TECHNICAL BULLETIN	
	August 2002
	TB 2000
Mfg:	FORD
Model:	F-SERIES
Liter:	4.2L
V I N:	2
Year:	97-08

Lower Intake Manifold Installation Procedure For
1996-03 Ford 3.8 & 4.2L VIN 4 & 2

Bulletin Diagram: INTAKE MANIFOLD INSTALLATION PROCEDURE - MANIFOLD

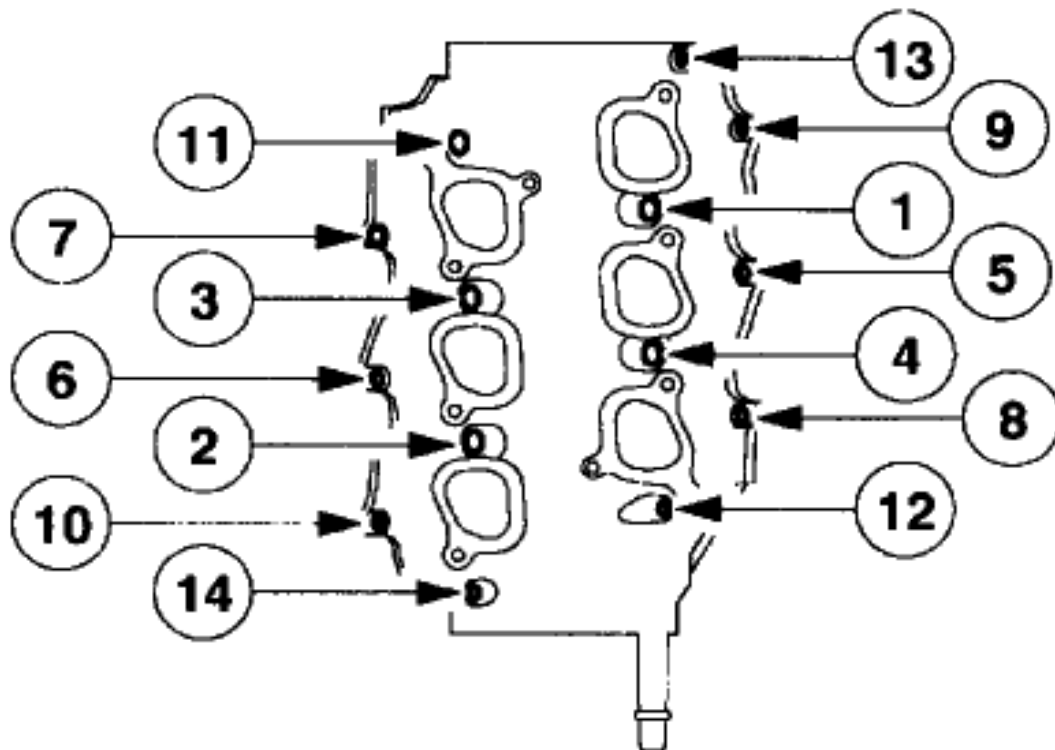
It appears that a new style thicker bead material being used on the intake lower manifold side seal gaskets has required a new installation procedure. These side seal gasket beads are larger and have been upgraded to eliminate the possibility of any internal engine coolant leakage.

Due to slightly thicker side gasket bead material, the center bolts locations 3 and 4 in the lower intake manifold must be installed first (hand-tighten) and then fastened. Drawing center bolts # 3 & # 4 first will help aligning up the other boltholes of the lower intake manifold. Doing so will allow a much easier lower intake manifold installation process.

To complete the installation of this manifold, reference the sequence shown in Figure 1. Torque the bolts to the revised torque of 71 inch/lbs (8 Nm) and then, an additional 90° of rotation.
